Deerwood Manor: Preliminary Plan No. 120160140

**Deerwood Manor: Preliminary Plan No. 120160140:** Request to create (6) six lots from two unplatted parcels; 500 feet west of the intersection of Riffle Ford Road and Darnestown Road/MD 28; 4.26 acres; R-200 zone; Potomac Subregion Master Plan.

**Recommendation** – *Approval with conditions*

Figure 3 – Preliminary Plan

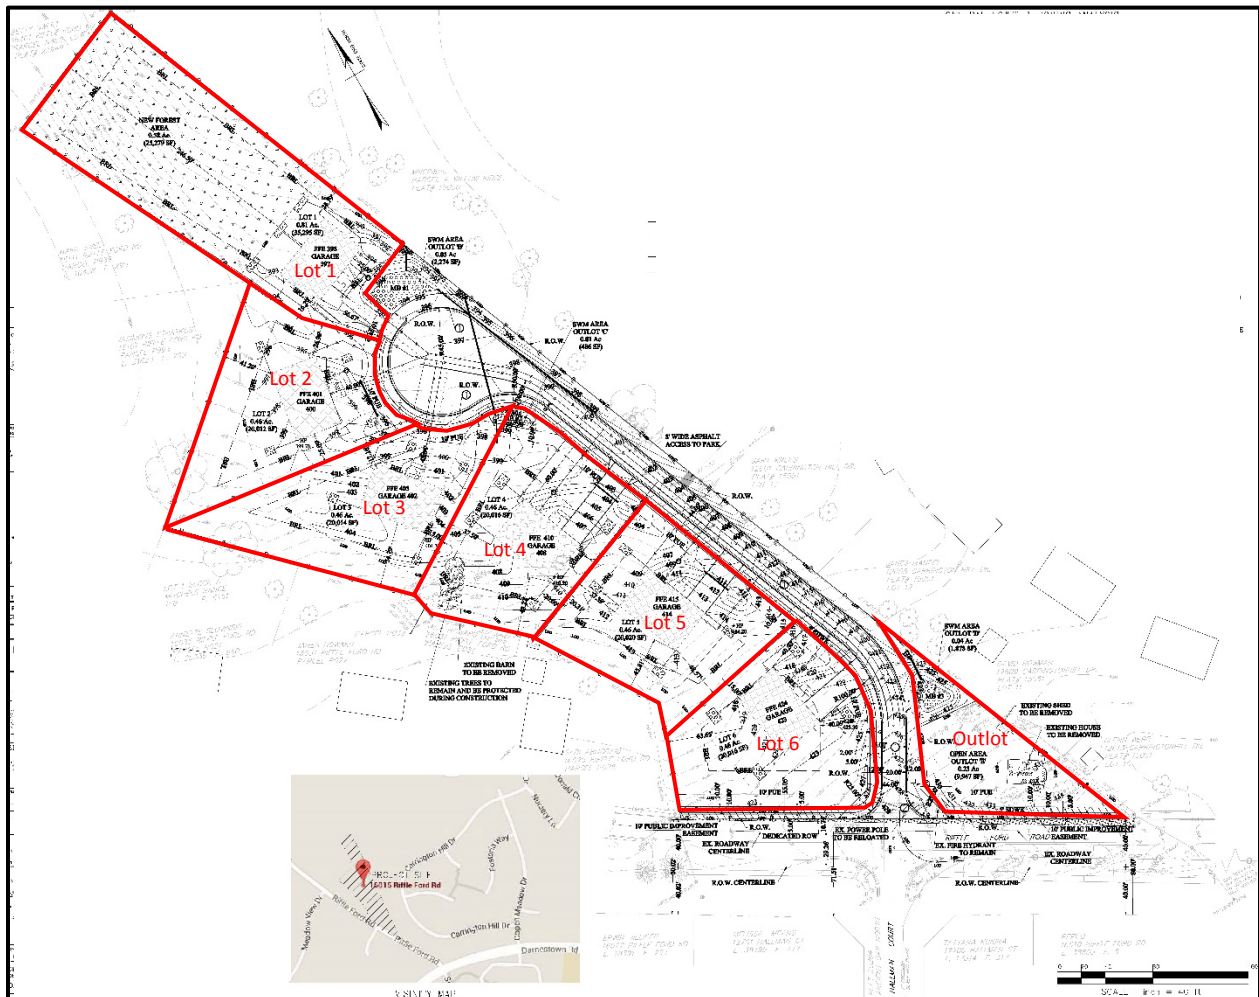
5. Prior to submittal of Certified Preliminary Plan, the Applicant must label the proposed public street as “Public Street A”.
  6. Prior to submittal of Certified Preliminary Plan, the Applicant must modify the rear building restriction line on Lot 1 to setback 232 feet from the rear property line.

- b. Public Street A: Dedicate a minimum of 44 feet of right-of-way and construct to MCDOT Road Code Standard MC-2001.01: Tertiary Residential Street with sidewalk on one side, as shown on the Certified Preliminary Plan.

8. The existing house on the Subject Property must be razed prior to the recording of a record plat.
  9. Prior to the submittal of Certified Preliminary Plan, the Applicant must modify the Public Utility Easement (PUE) and Public Improvement Easement (PIE) along Riffle Ford Road to show a 20-foot PUE from the right-of-way line with an overlapping 10-foot PIE starting from the right-of-way line.

Figure 4 - Protected Trees to be removed (red X) and retained but impacted (green dot)

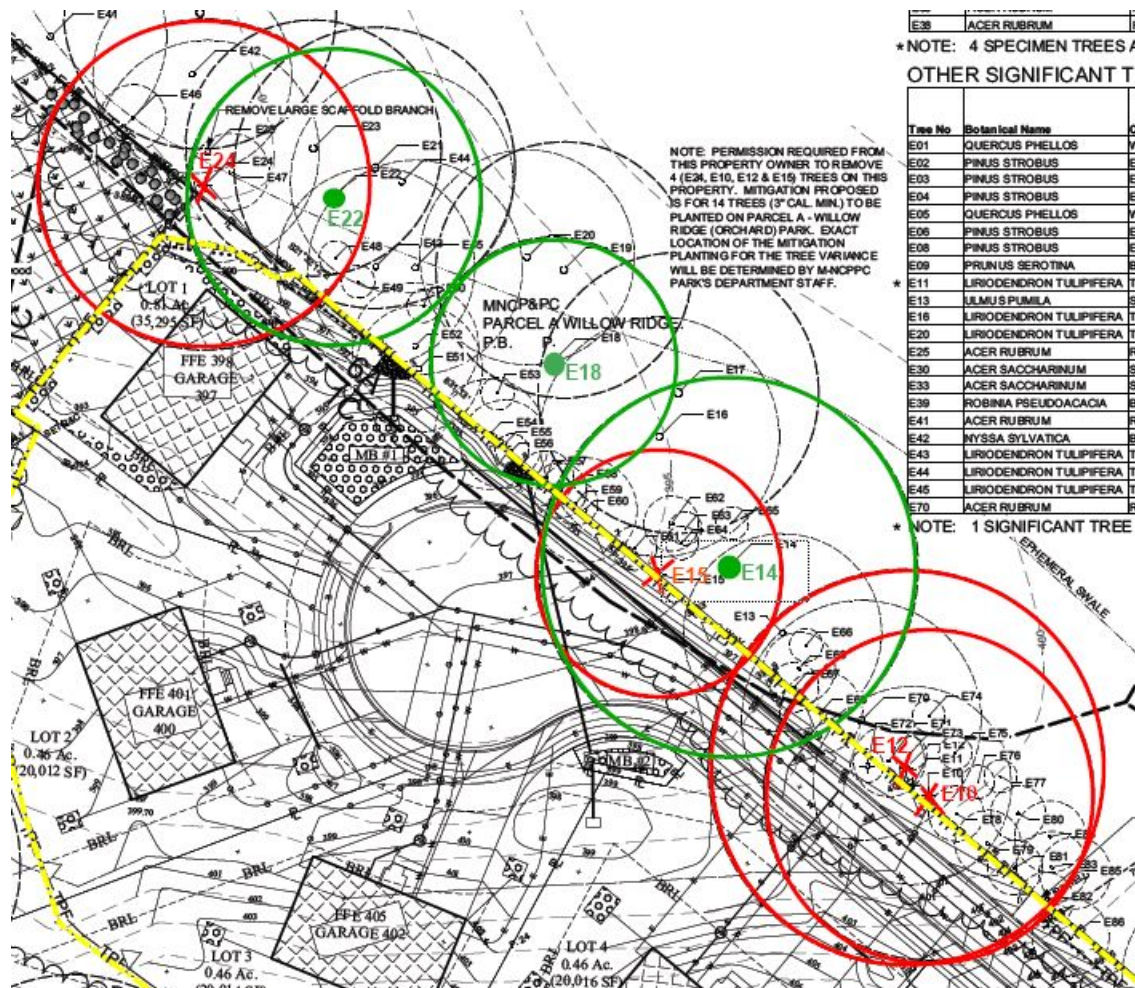
Variance Request – The Applicant submitted a variance request in a letter dated November 11, 2016, for the impacts/removal of trees (Attachment 10). The Applicant proposes to remove four (4) Protected Trees that are 30 inches or greater, DBH, and considered a high priority for retention under Section 22A-12(b)(3) of the County Forest Conservation Law. These trees are noted as E10, E12, E15, and E24 on the FCP, listed in Table 2, and shown graphically in Figure 4. The Applicant also proposes to impact, but not remove, five (5) Protected Trees that are considered high priority for retention under Section 22A-12(b)(3) of the County Forest Conservation Law. The critical root zones of these off-site trees will be impacted during the grading for the proposed lots and construction of the proposed road that provides access to the lots. Details of the Protected Trees to be affected but retained are listed in Table 3 and shown graphically in Figure 5.

Mitigation for Protected Trees – Mitigation for the removal of the four Protected Trees is recommended at a rate that approximates the form and function of the trees removed. Therefore, Staff is recommending that replacement occur at a ratio of approximately one-inch caliper for every four inches removed, using trees that are a minimum of three caliper inches in size. This Application proposed to remove 158 inches in DBH, resulting in a mitigation requirement of 40 caliper inches of planted, native, canopy trees with a minimum size of three-inch caliper. The FCP includes the planting of 14 native, canopy trees as mitigation for the removal of the four variance trees. Although these trees will not be as large as the trees lost, they will provide some immediate benefit and ultimately replace the canopy lost by the removal of these trees. Since the four Protected Trees to be removed are located along the property line and just off-site on M-NCPPC Park property, the mitigation trees will be planted on the adjacent park land under the direction of M-NCPPC Planning Department Staff Inspectors and the Parks Department Staff. If suitable locations are not identified on the adjacent park site, the trees will be planted on the Property. Staff does not recommend mitigation for trees affected, but not removed. The affected root systems will regenerate and the functions provided restored.

- g. Mitigation must be provided for the removal of four variance trees. Mitigation must be provided in the form of planting fourteen native canopy trees with a minimum planting

SCALE 1" = 40'  
 SHEET C-2 of 6

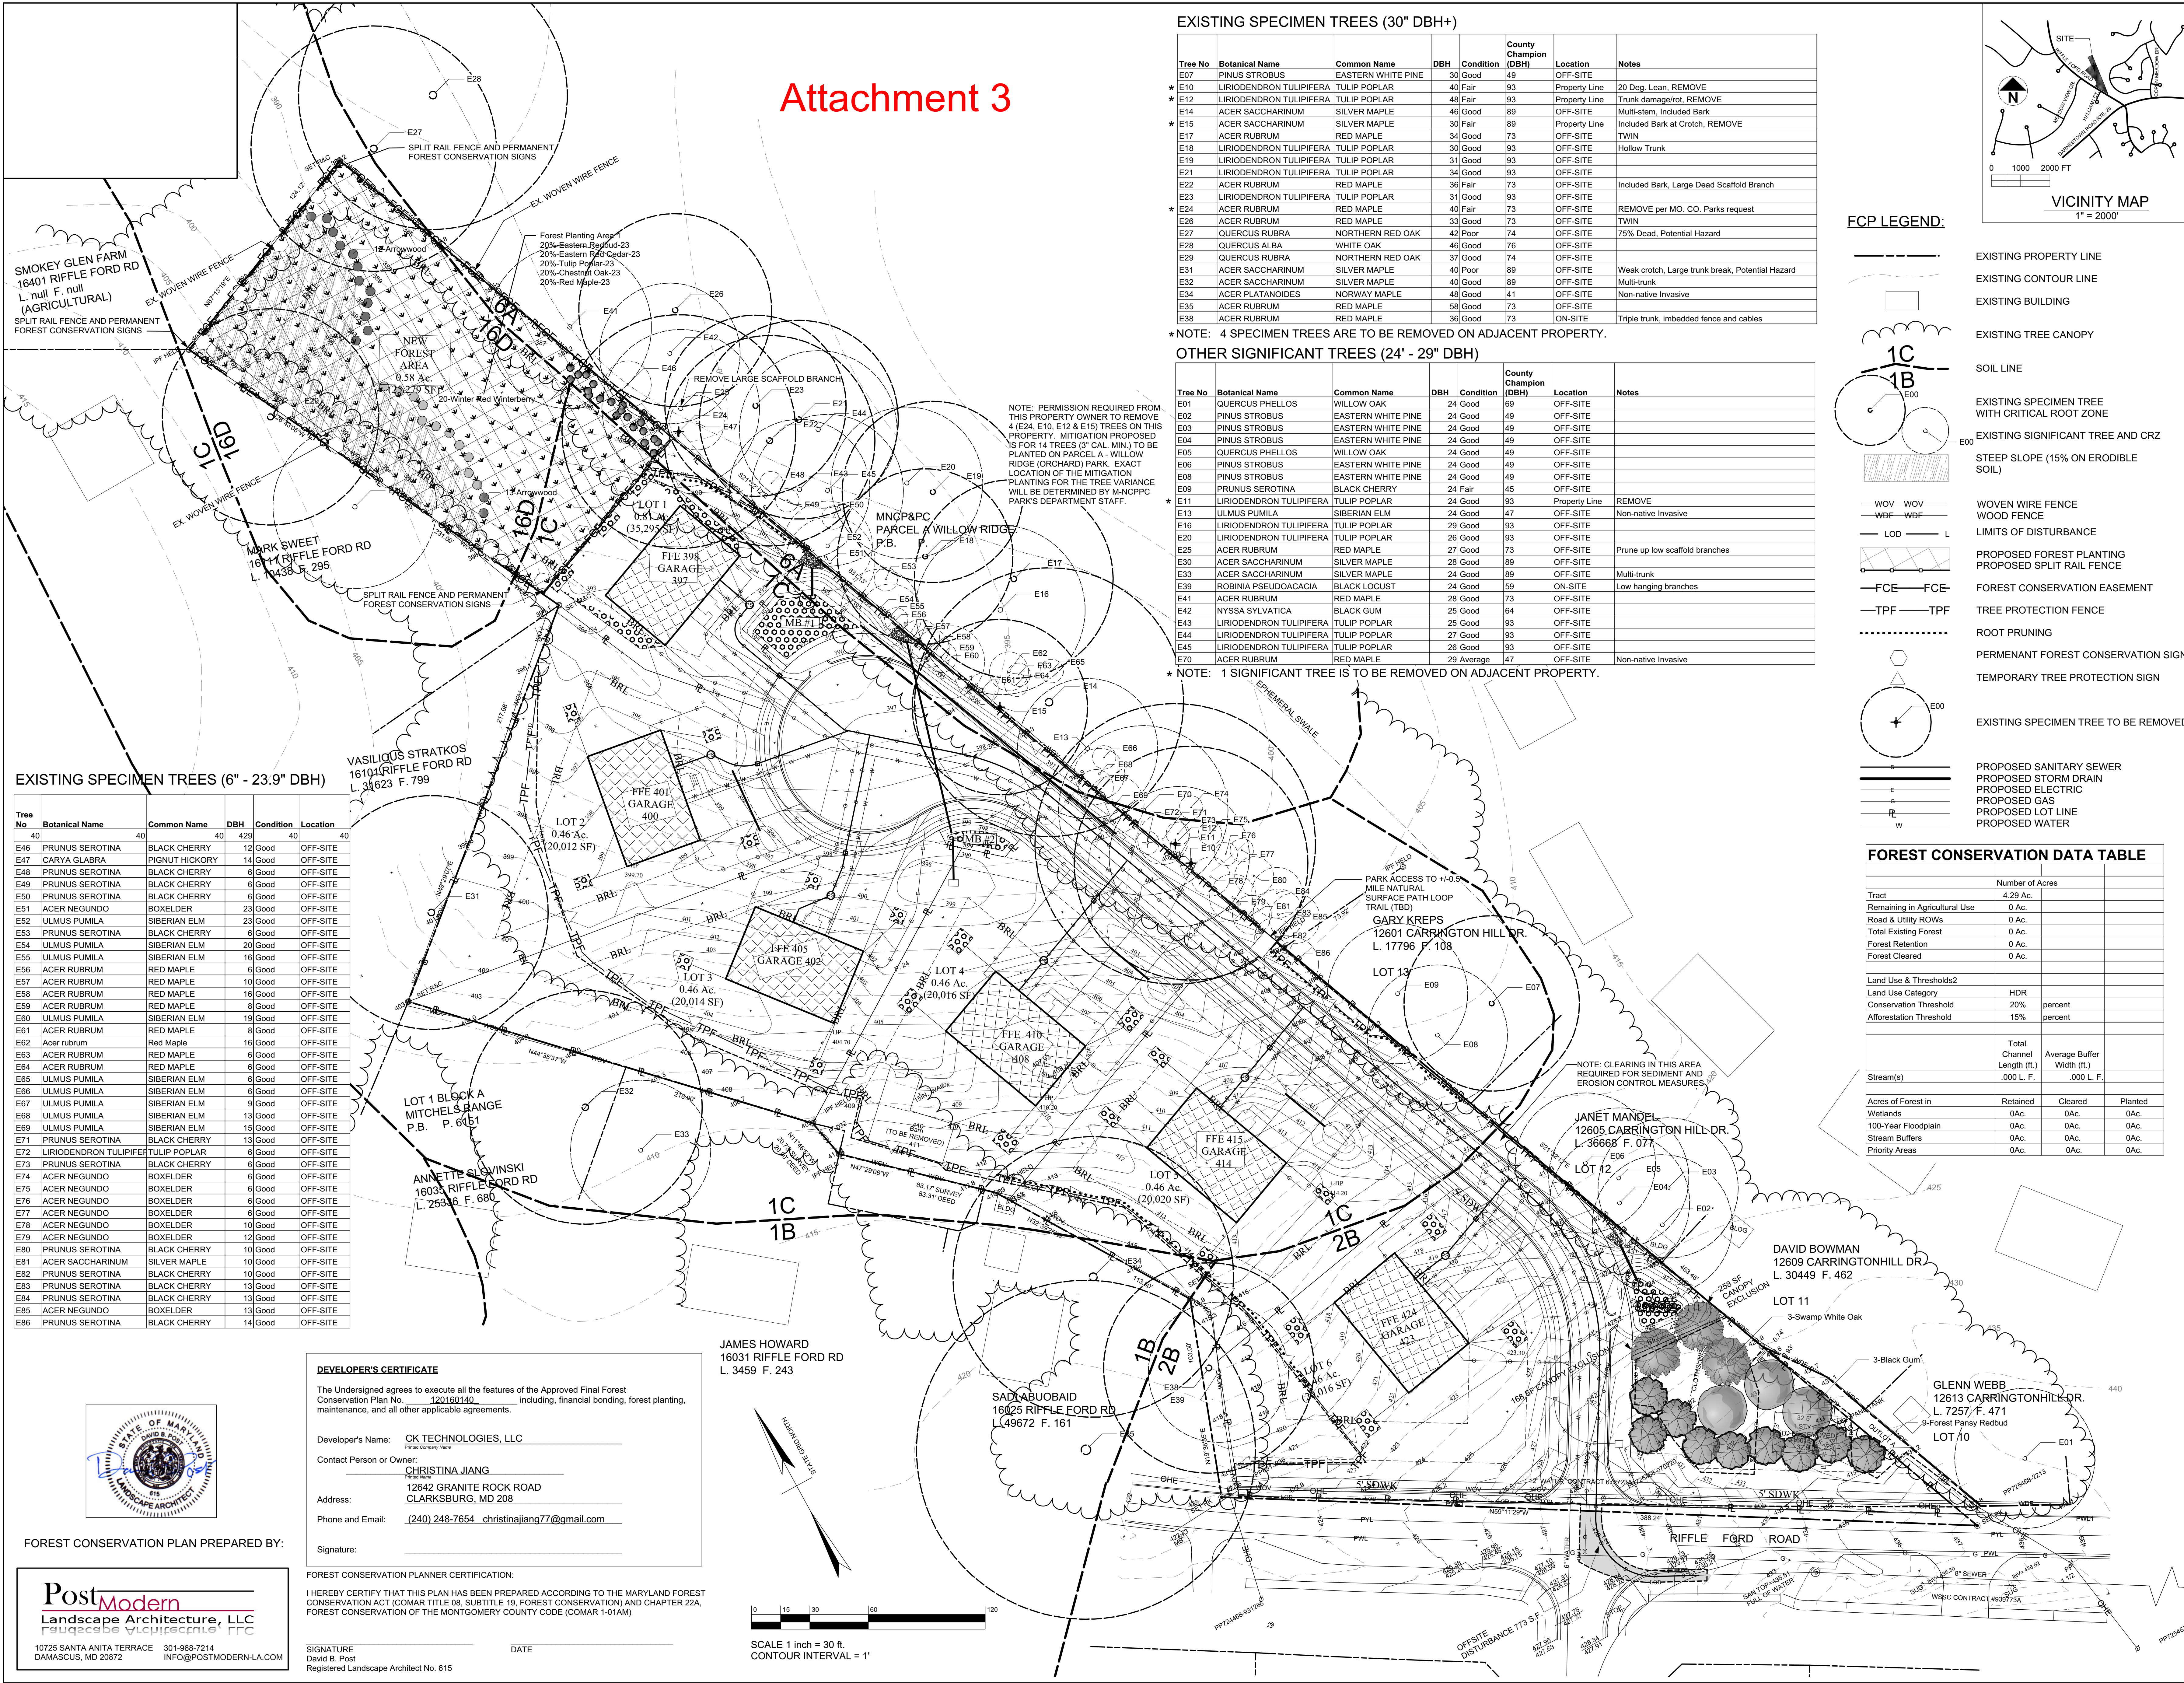
5. The typical section for Riffle Ford Road is not consistent with the Master Plan intentions, nor does it reflect the proposed interim improvements (due to the existing offset roadway pavement per Note 1 on the plan). We recommend this typical section be replaced, prior to Certified Preliminary Plan, with a site specific detail showing the proposed temporary improvements.

7. The sight distance evaluation should be updated (to reflect the correct posted speed limit for Riffle Ford Road) and resubmitted for Executive Branch approval prior to Certified Preliminary Plan.

8. The storm drain study is incomplete and has not been approved. Environmental Site Design (ESD) and reduced runoff curve numbers cannot be credited to reduce the ten (10) year post development storm drain calculations. This detail will need to be addressed at the permit stage.
